TO: Technical File *KW*  
FROM: Kent Wheeler, Reclamation Hydrologist  
RE: Sediment Pond Decant Modification (Dated 3-31-87), Utah Fuel Company, Skyline Mine, ACT/007/005, Folder No. 2, Carbon County, Utah

Project: Skyline Sediment Pond - Stage Discharge  
 Date: 7-6-87  
 Reviewer: Kw

# Stage Discharge Curve for Modified Skyline Sediment Pond

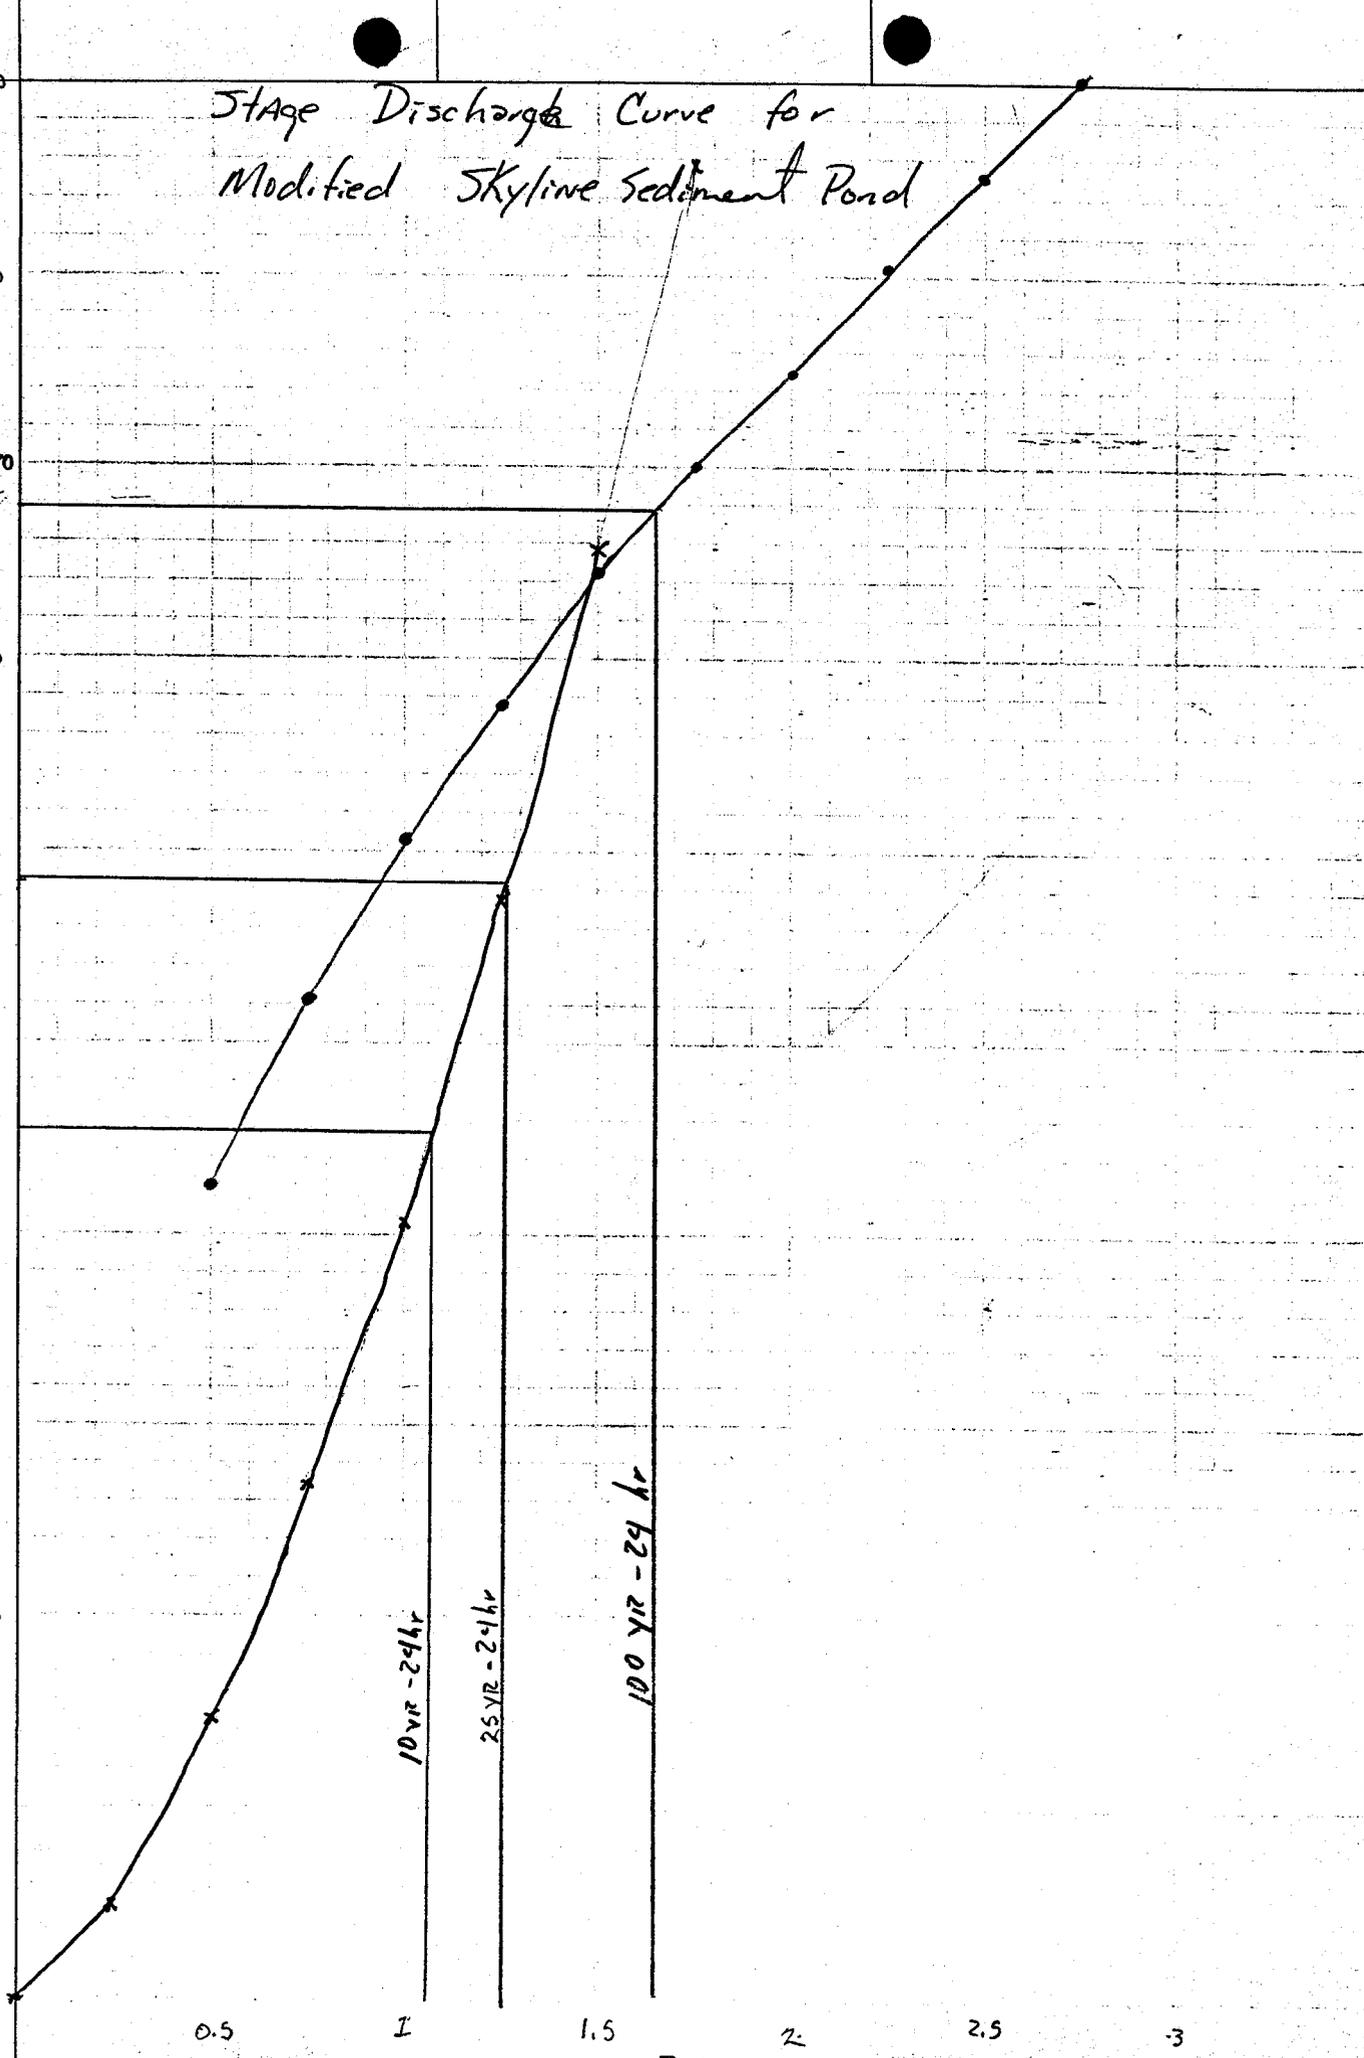
Maximum water elevation during 100 yr - 24 hr storm event 8581.2 ft

available freeboard 1.5 ft

∴ design modification should be approved after conditions are met.
